Service Letter

Service Letter: No. 336

Subject: Bell 412 Air Conditioner Receiver Drier Upper Support Bracket

Applicability: Bell Helicopter Model 412

Figure 1-2, Receiver Drier Bottle Support Bracket Mounting

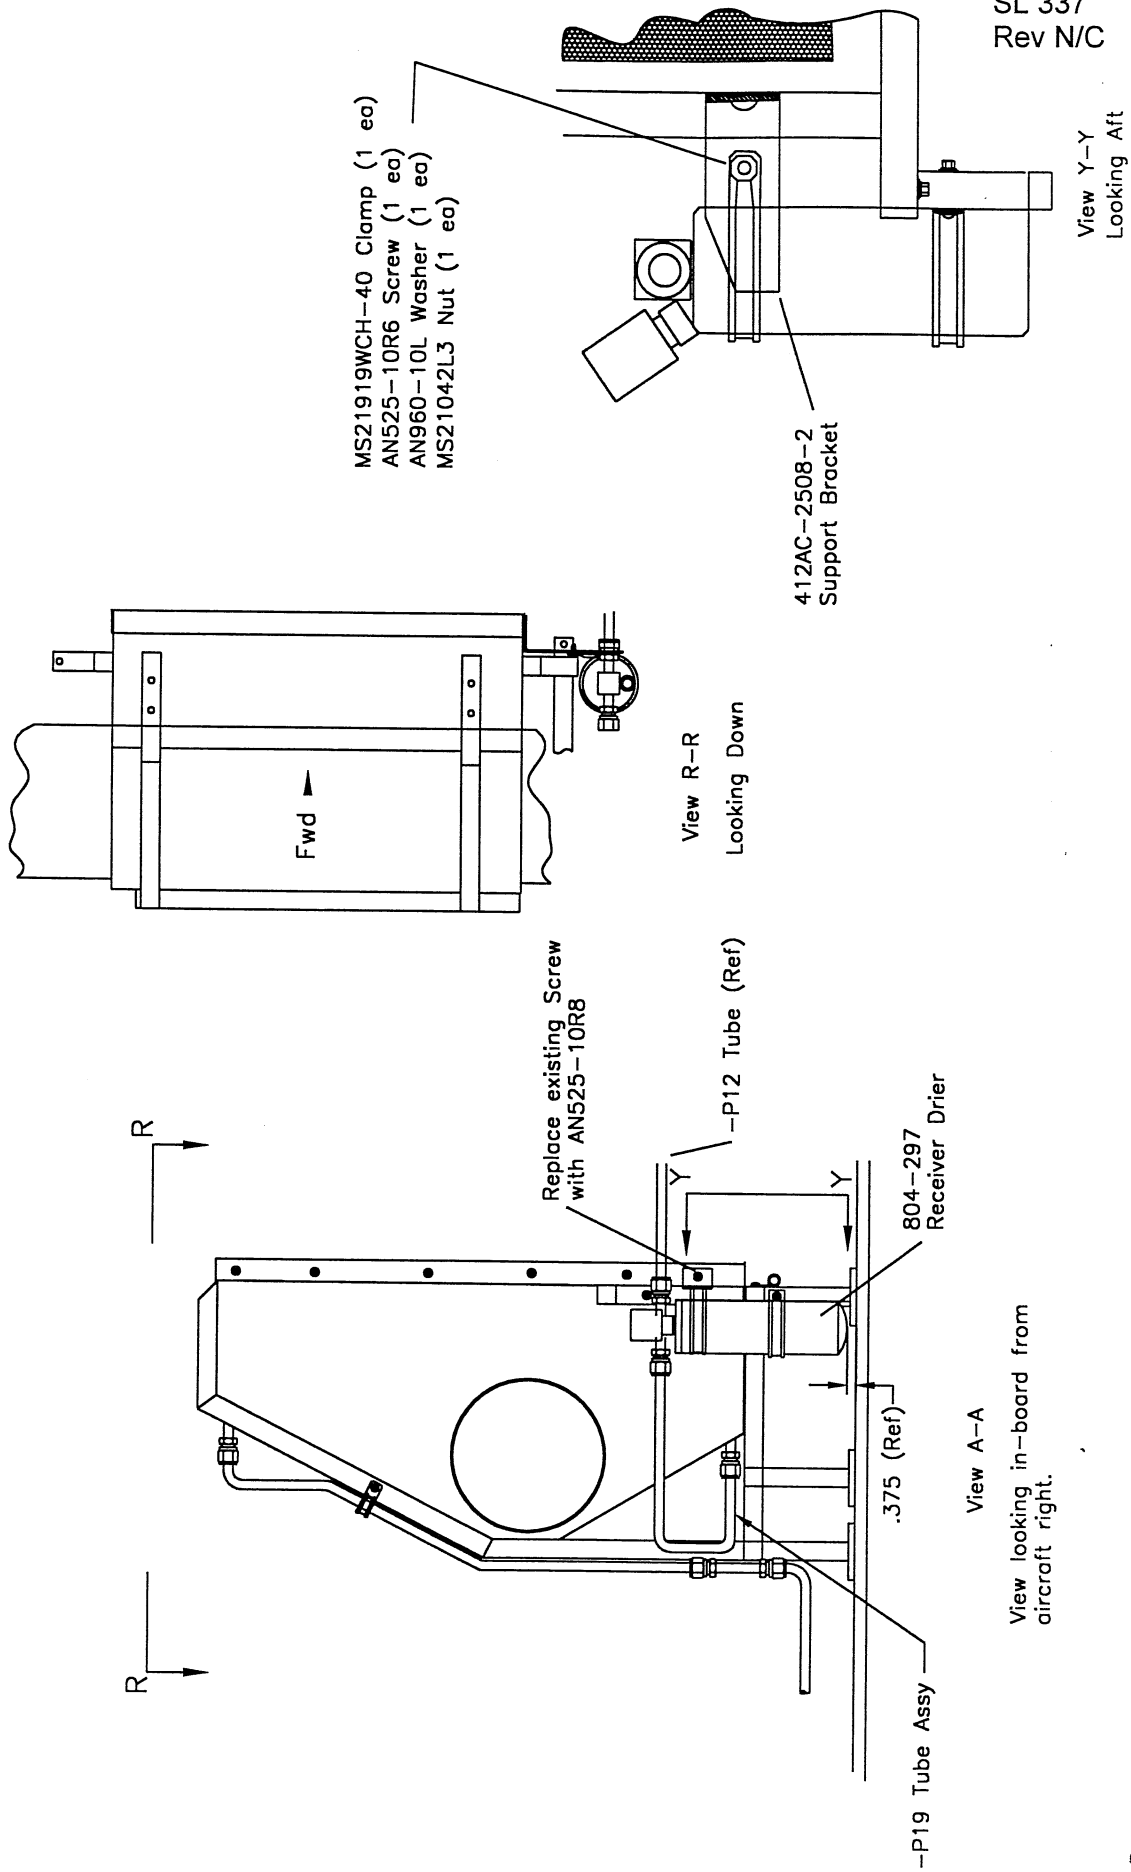
Background: We have received a report from the field that the current configuration of the Bell 412 air conditioner receiver drier support clamps may allow the top of the Receiver Drier assembly to shift. This shift may cause the fittings to leak or crack, causing the system refrigerant to leak.

2. Remove one (1) each of a AN525-10R6 Screw, from the lower R/H forward corner of the Condenser Enclosure Assembly. (See Fig. 1-2, View A-A)

1. Align the 412AC-2508-2 Bracket with the Screw Hole left vacant from the removal of the AN525-10R6 Screw in the lower R/H forward corner of the Condenser Enclosure Assembly, and match drill using a .1890 Dia drill bit. (See Fig. 1-2 View A-A)

Remove all sharp edges for match drilled hole in 412AC-2508-2 Bracket.

2. Install one each AN525-10R8 Screw to attach the 412AC-2508-2 Bracket to the Condenser Enclosure Assembly.
3. Install one each of the MS21919WCH-40 Clamp on the upper portion of the 804-297 Receiver Drier Bottle. Rotate Clamp to align with the aft surface of the 412AC-2508-2 Bracket, and mark location of hole. (See Fig. 1-2, View Y-Y).

Insure that the Receiver Drier Bottle remains in a "relaxed" position, as not to put a pre-load on the connecting refrigerant lines.

4. Match drill using a .1890 Dia drill bit in out-board section of 412AC-2508-2 Bracket, and install the MS21919WCH-40 Clamp, AN525-10R6 Screw, AN960-10L Washer, and MS21042L3 Nut as shown in View Y-Y.
5. Reinstall the upper transmission cowling.
